MONTGOMERY COUNTY PLANNING DEPARTMENT
THE MARYLAND-NATIONAL CAPITAL PARK AND PLANNING COMMISSION

MCPB
Item No.: 7B
Date: 11-07 2019

Primrose Schools CU-18-08: Day Care Center

Figure 9 Proposed Landscape Plan

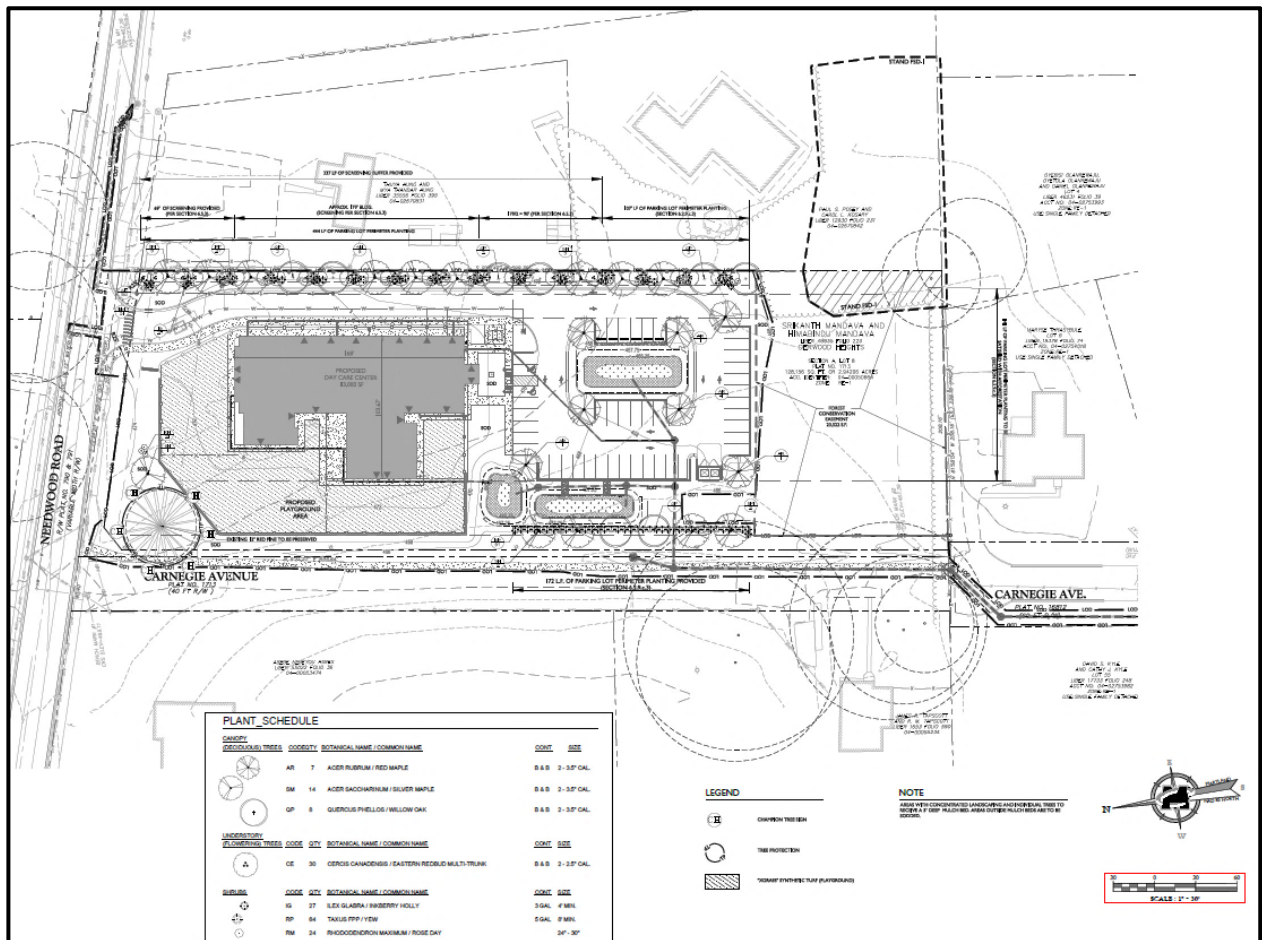
The submitted Landscape Plan revised on October 21, 2019 satisfies these requirements.

The Application complies with the 100 square foot and five percent requirement for the size of landscaped islands by providing landscaped islands accounting for six percent of the parking area.

The proposed Landscape Plan shows that the tree canopy requirements under Section 59-6.2.9.C.2 have been met by the installation of seven red maple trees, providing a 44 percent coverage for the 28,432 square foot parking lot at 20 years.

The Application meets the requirements by providing a perimeter parking buffer that is 12 feet wide along the eastern property line, 39.86 feet wide along the western property line and utilizing existing trees and proposed afforestation.

Figure 12: Proposed Wall Sign

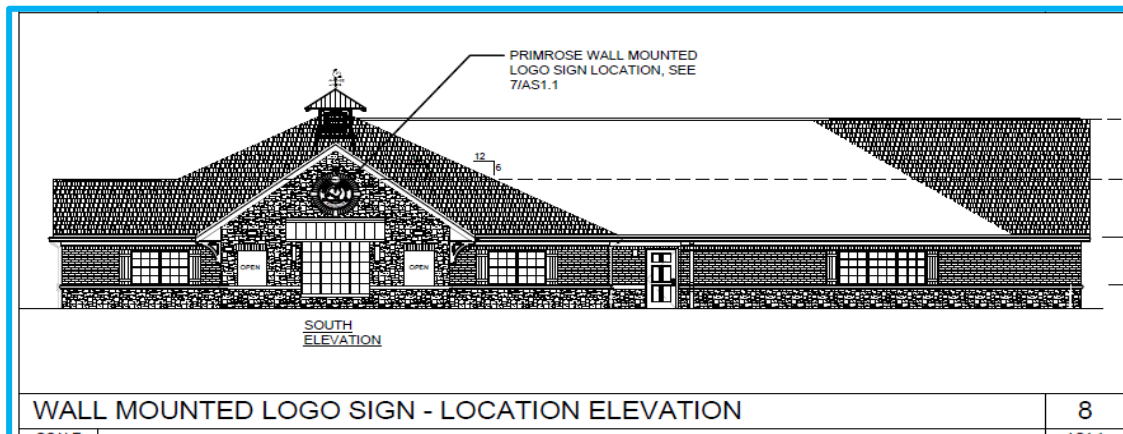
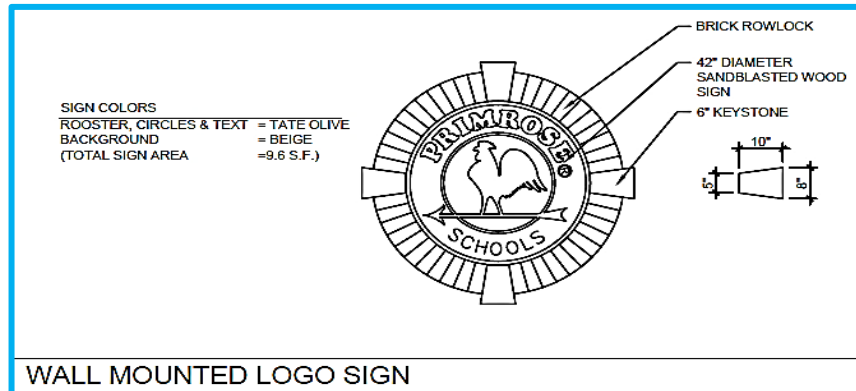
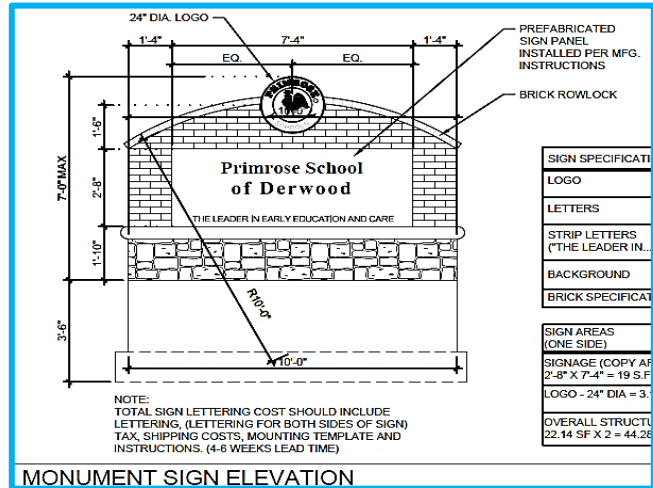
The Application proposes a wall mounted logo sign that will be placed on the south side of the building. The sign meets the requirements for wall signs.

Figure 14: Proposed Building Elevations

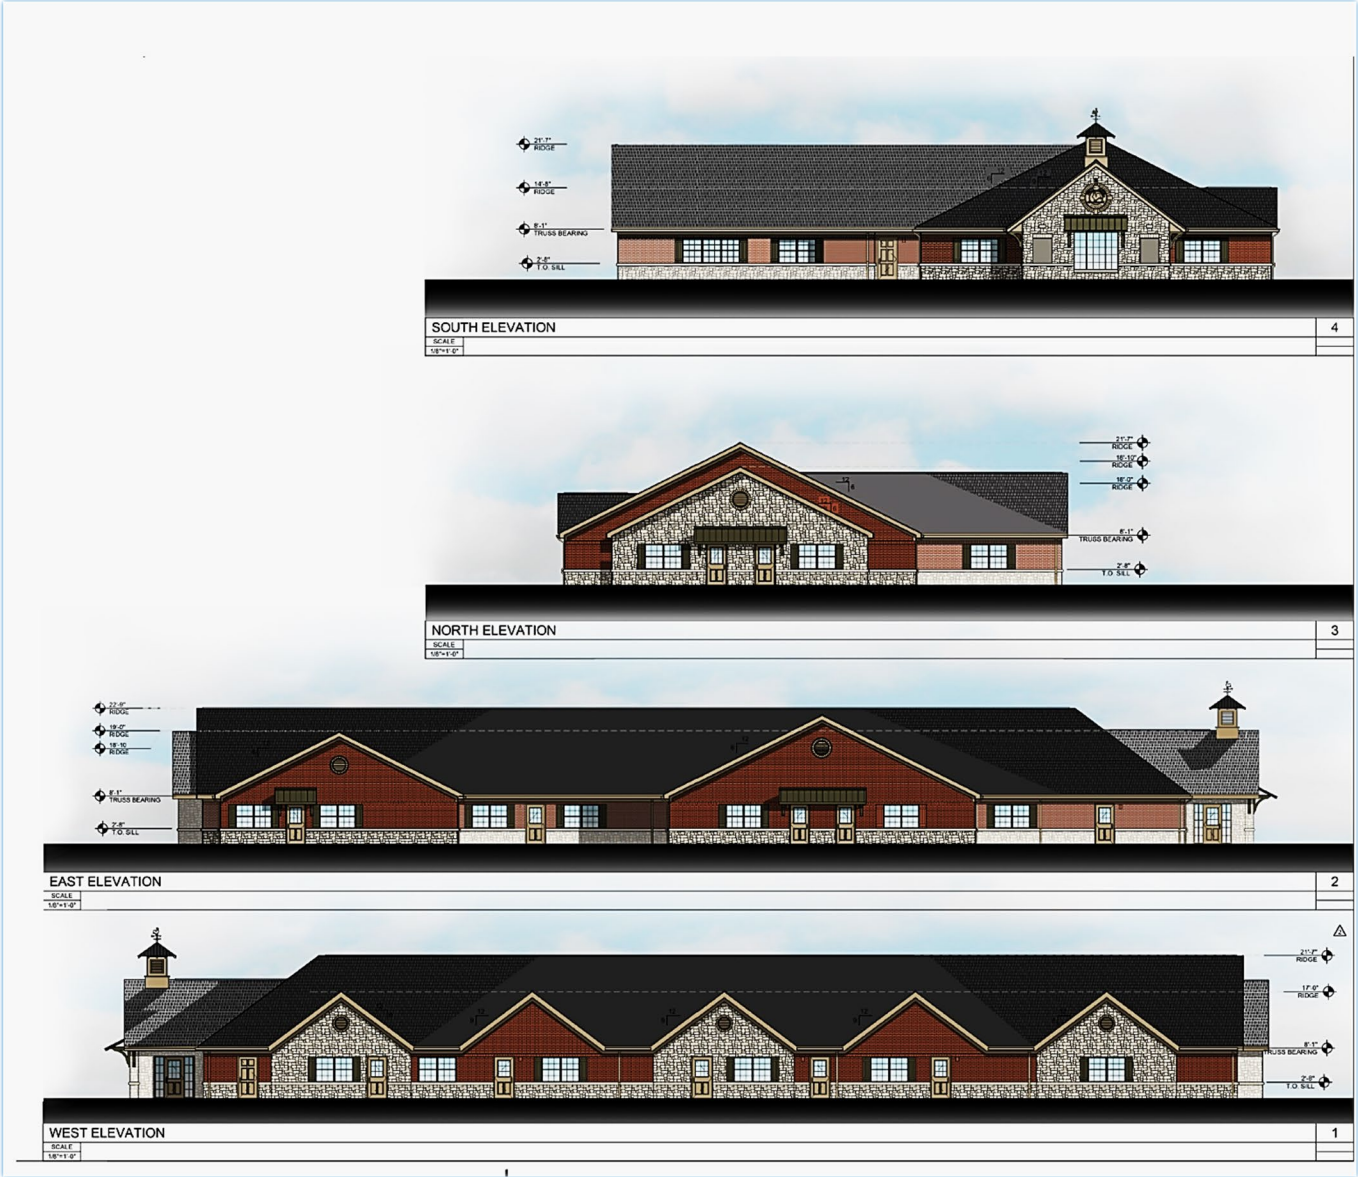
With the recommended conditions, the proposed use will be in harmony with the general character of the neighborhood. The Conditional Use Site Plan and the Landscape and Lighting Plan provide for extensive landscaping and, adequate setbacks, meeting code requirements.
